Project:	Sackville School, East Grinstead	Scheme No:	15609
Subject:	Technical Note- Response to LLFA comments	Revision:	01
Client:	Sackville School, East Grinstead	Date:	10/07/2025
Doc Ref:	15609-Flood Risk and Drainage Technical Note-01		
Author:	Jessica Joy BSc (Hons) MCIWEM		
Checker	Aled Williams BSc (Hons) MCIWEM C.WEM

This Flood Risk and Drainage Technical Note has been prepared to provide additional information to support a planning application (reference: DM/25/0263) for 2no. artificial sports pitches at Sackville School, Lewes Rd, East Grinstead, RH19 3TY.

The purpose of this Technical Note is to provide supporting information to avoid the requirement for surface water drainage related planning condition.

Project name:	Sackville School
Project type:	Outdoor Sports Facility Development
Drawing:	Drainage Plan
Reference:	NSSS009
Revision:	B
Date:	07/07/25
Drawn by:	JP
Scale / Size:	1:400 / A1

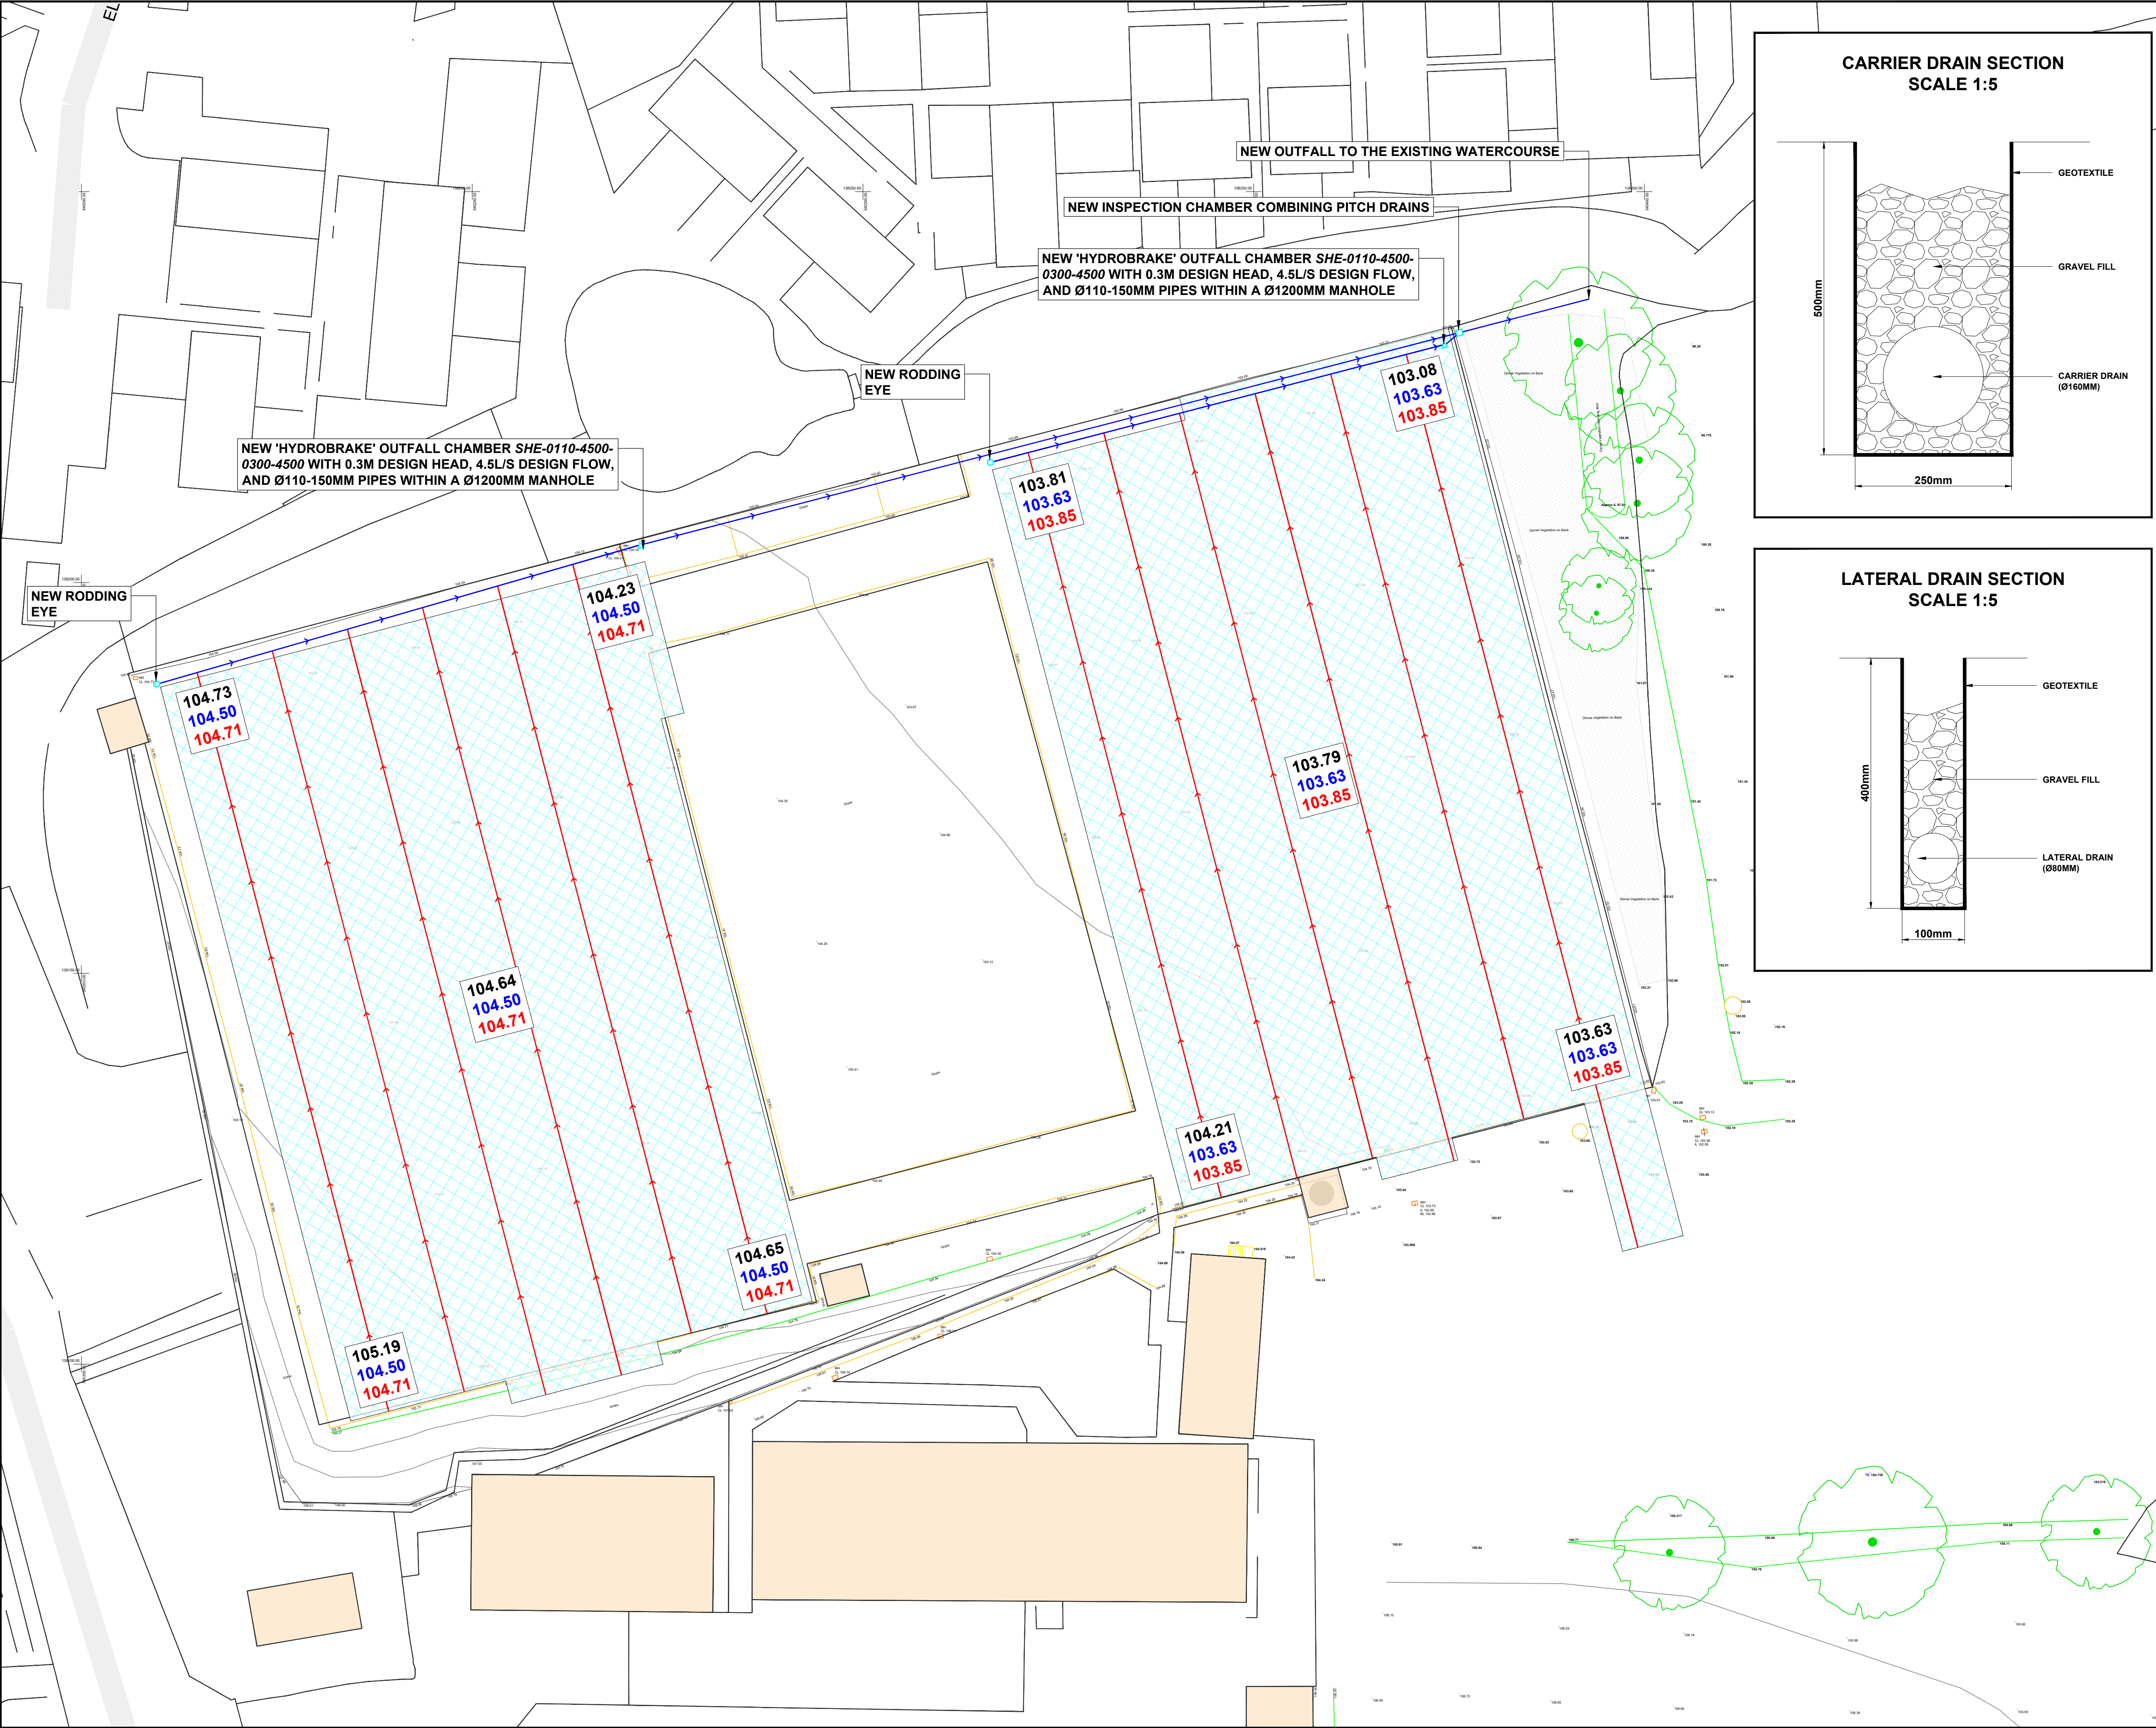
The applicant is advised that evidence will need to be provided at the detailed design stage that there is sufficient fall to connect to the existing watercourse on the school grounds.

The development hereby permitted shall not commence unless and until details of the proposed surface water drainage and means of disposal have been submitted to and approved in writing by the local planning authority. The pitches shall not be brought into use until all the approved drainage works have been carried out in accordance with the approved details.

- 1) Drainage Plan (Drawing No. NSSS009), included in Appendix A – This drawing shows the existing and proposed finished levels of the pitch, the carrier drain and lateral drain sections. The drawing also shows the location of the Hydrobrake flow control chambers and the pipe route to the outfall. The ditch to the east of the site (outfall) is situated at approximately 97.7m AOD and 5.69m below the lowest site level. As such, a gravity connection can be achieved.
- 2) Hydrobrake chamber detail, included in Appendix B together with the detail of the outfall headwall.
